Addendum No. 3
Four Rivers Sanitation Authority
Collection Systems Operations Facility
Capital Project No. 2217

This Addendum No. 3, dated February 14, 2023, for the above referenced project, supersedes all contrary and conflicting information in the specifications and contract documents, which are hereby supplemented or revised as follows:

New Collection
Systems Operation
Facility

PARTIAL FLOOR PLAN - PLUMBING
SCALE: 1/4" = 1'-0"

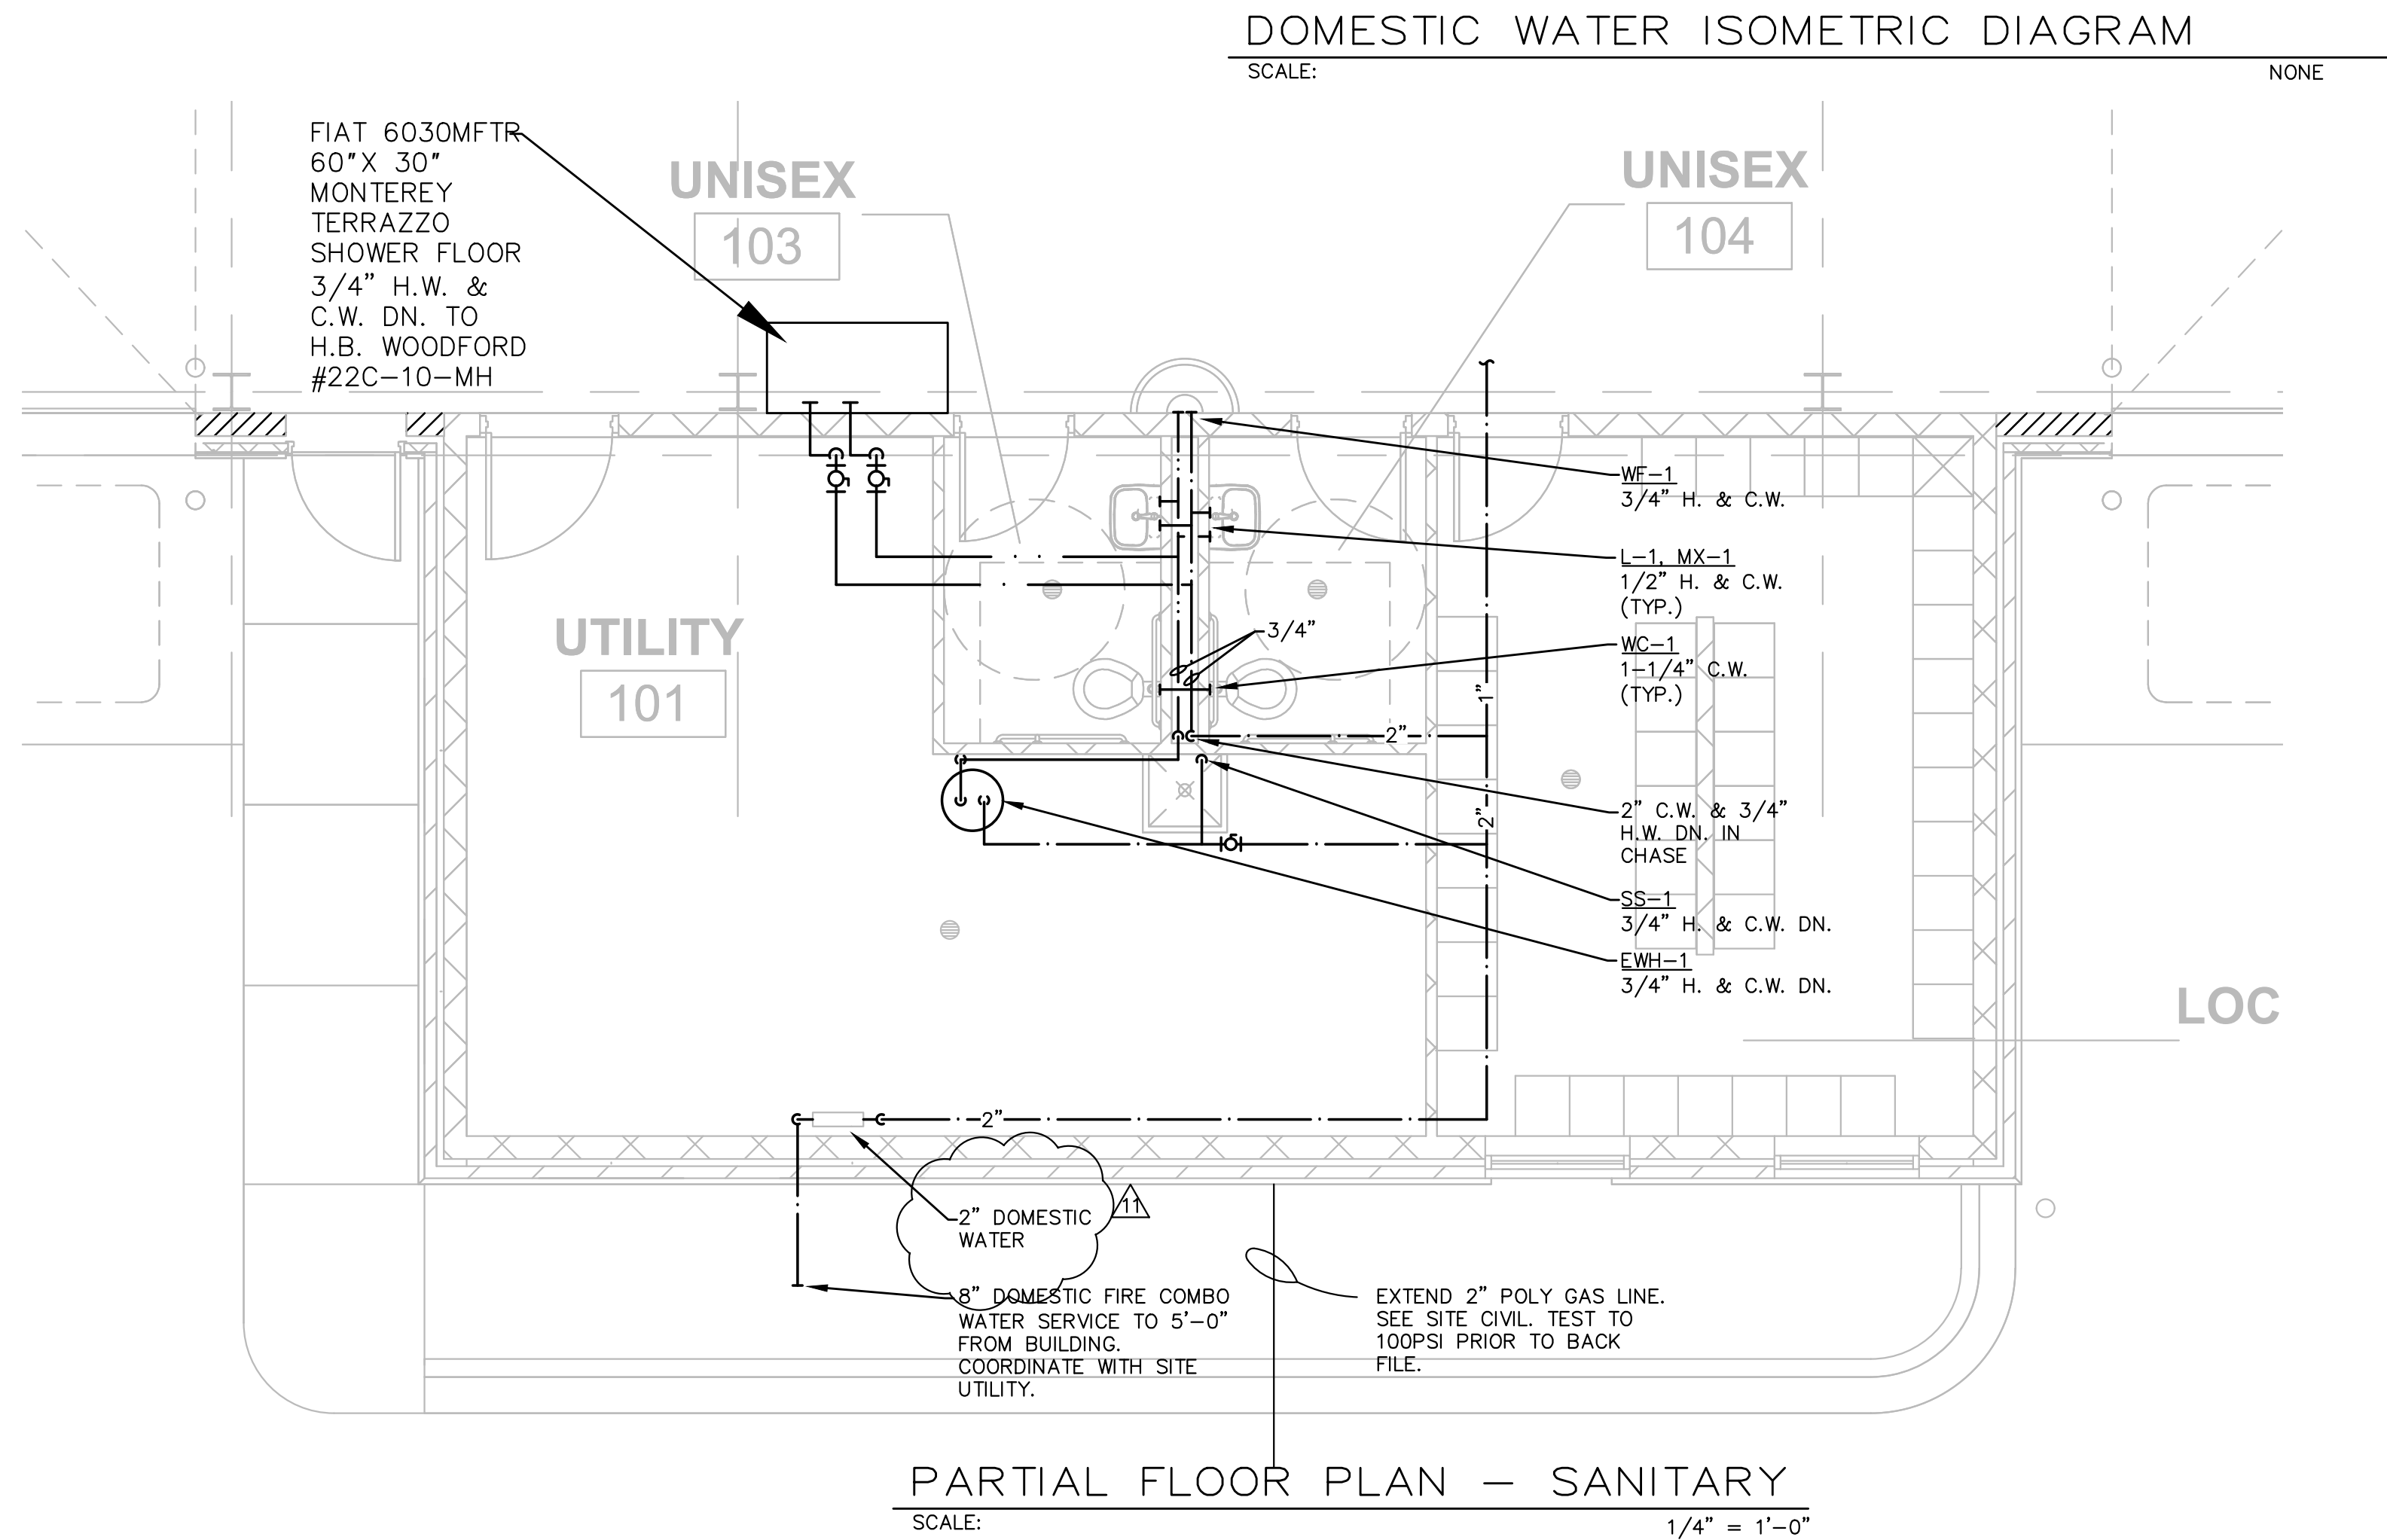
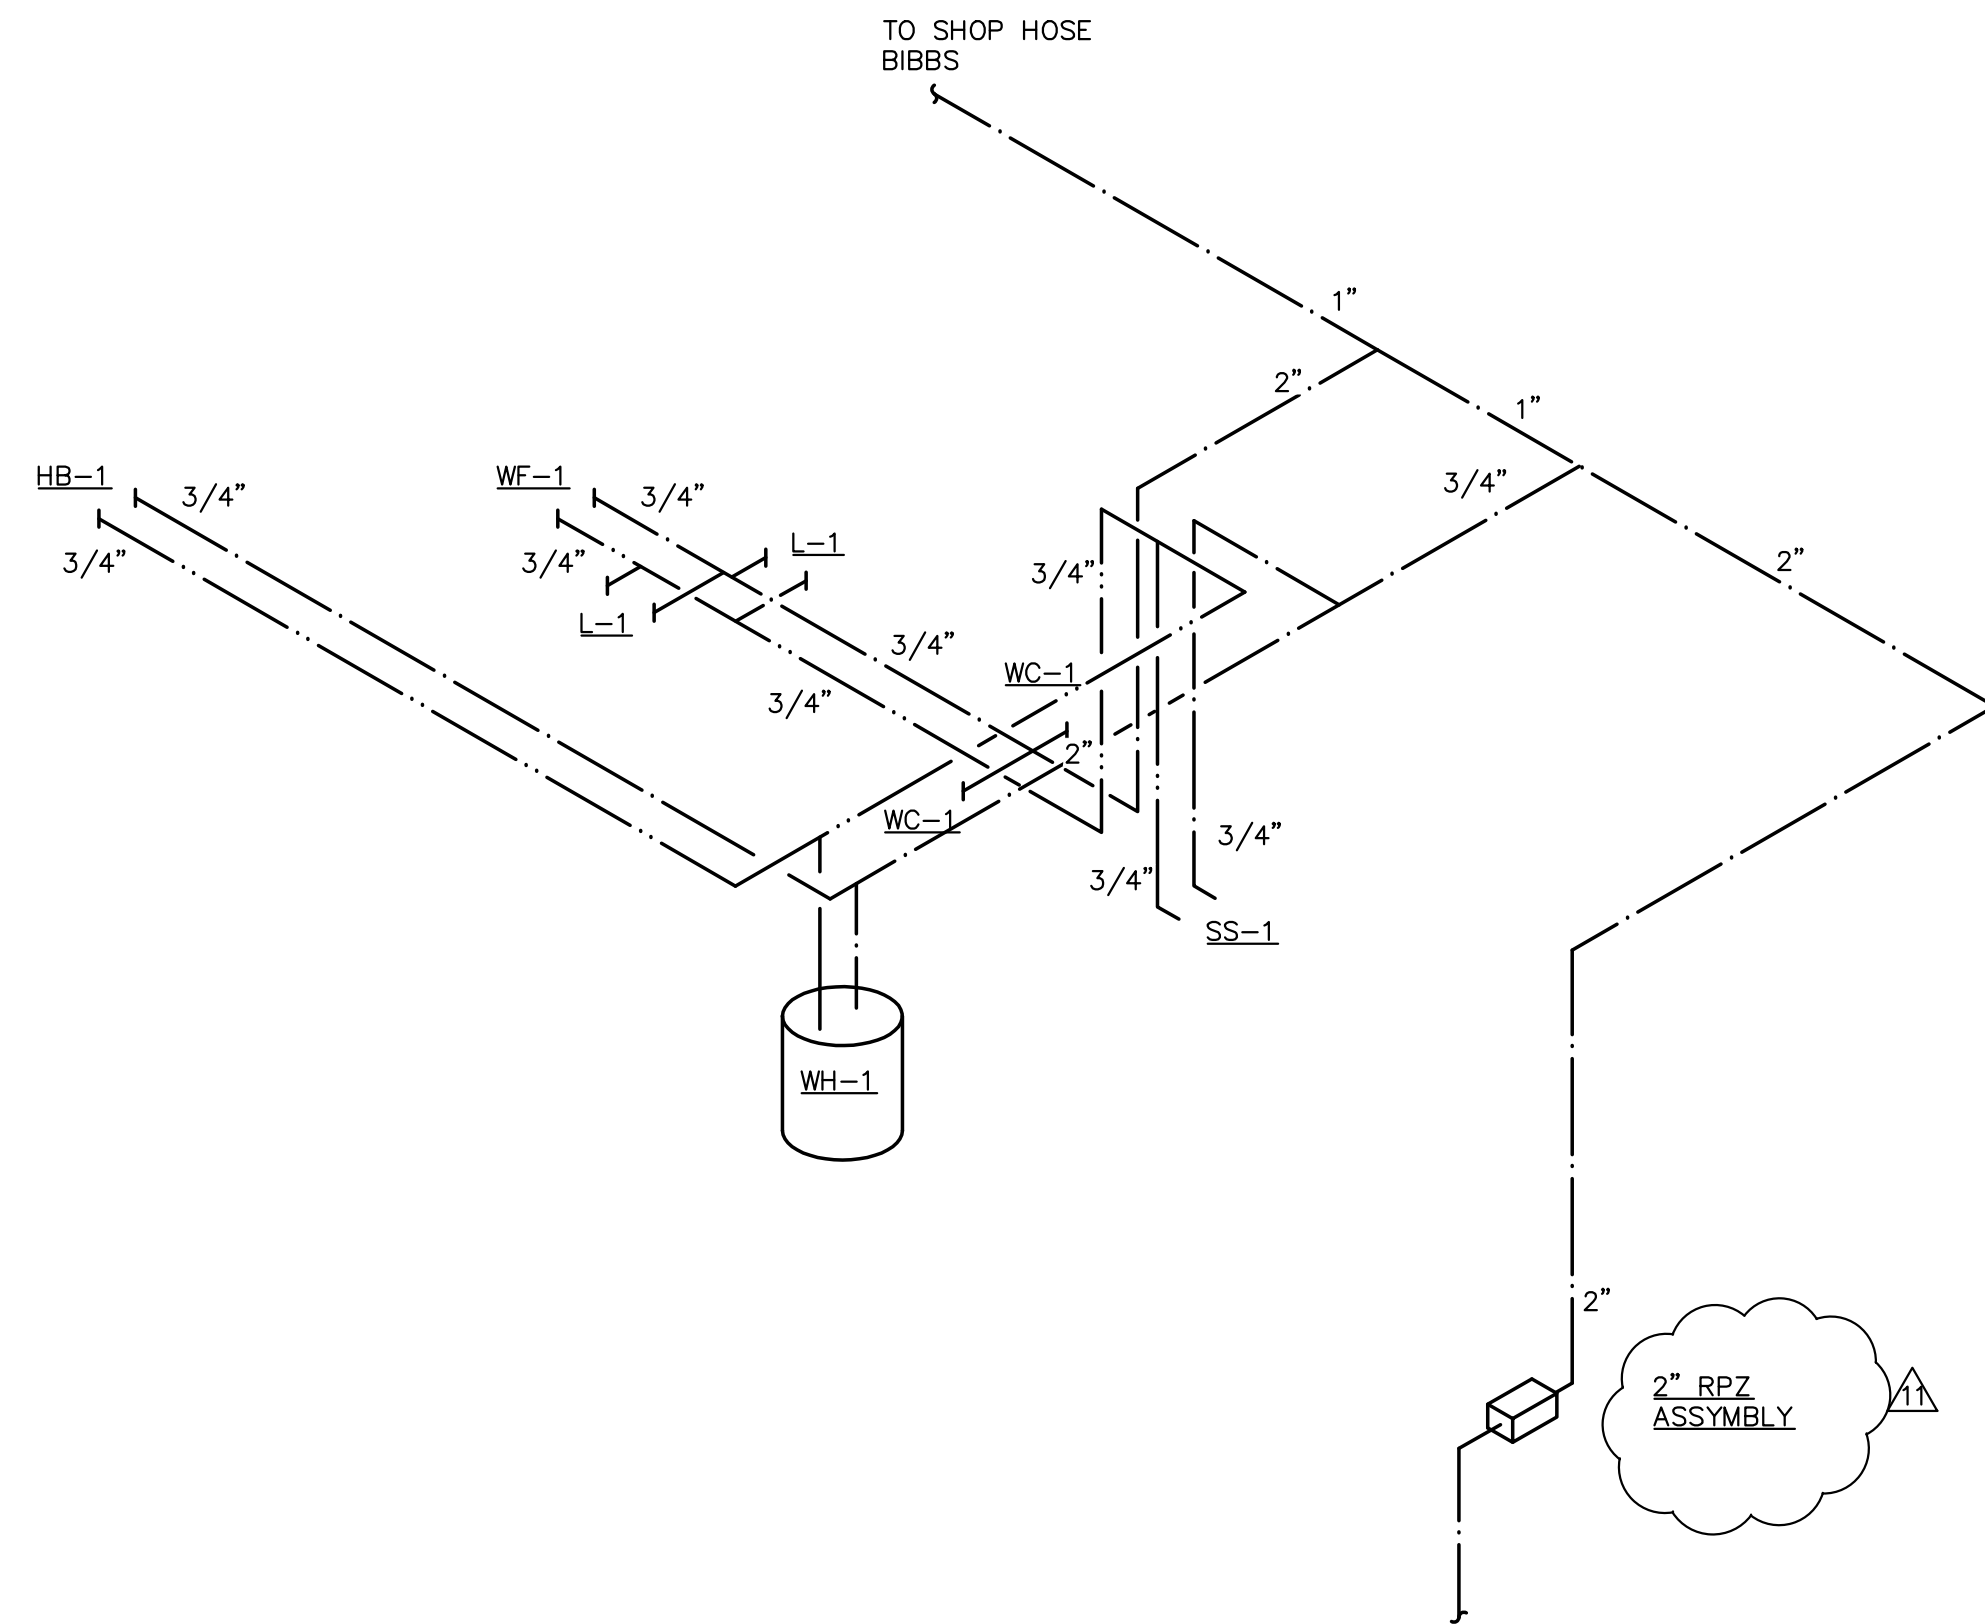
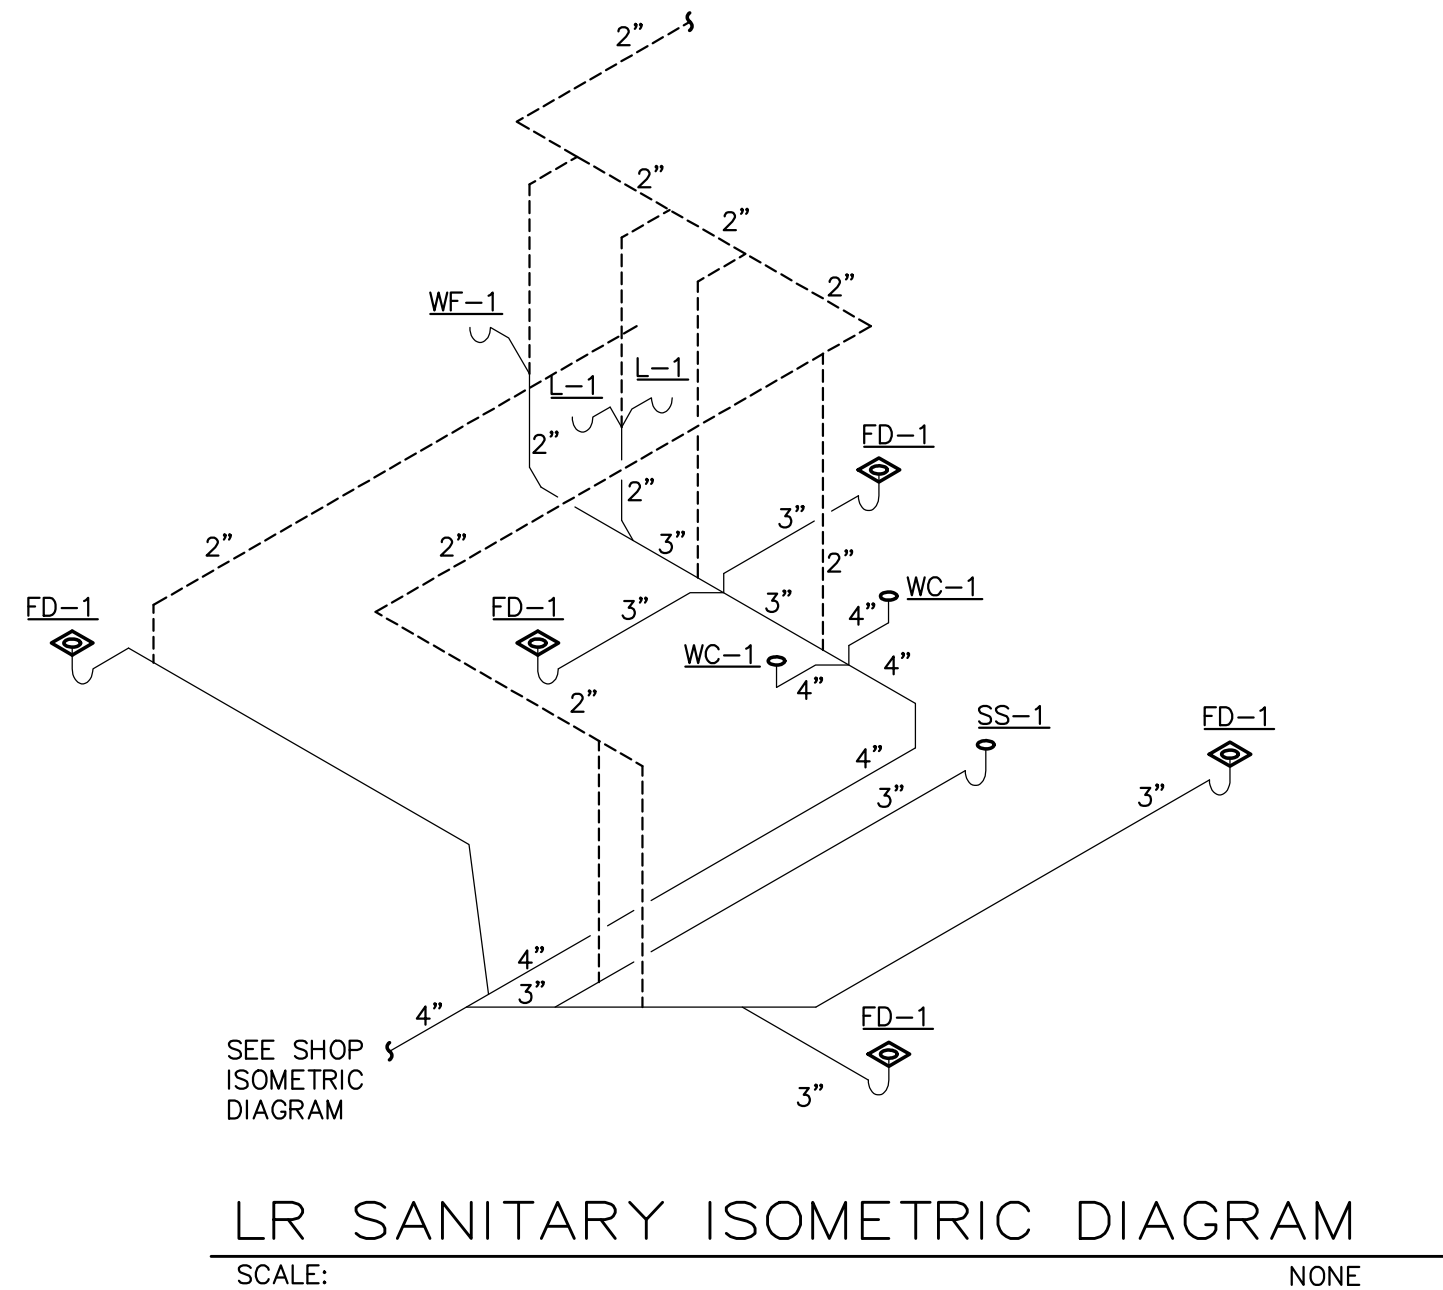
37. Is the overhang roof drain and bump out roof drain tied together inside the building and then exit as a 10"?

Response: *Reference revised Plan Sheets P101 and P102 for clarification.*
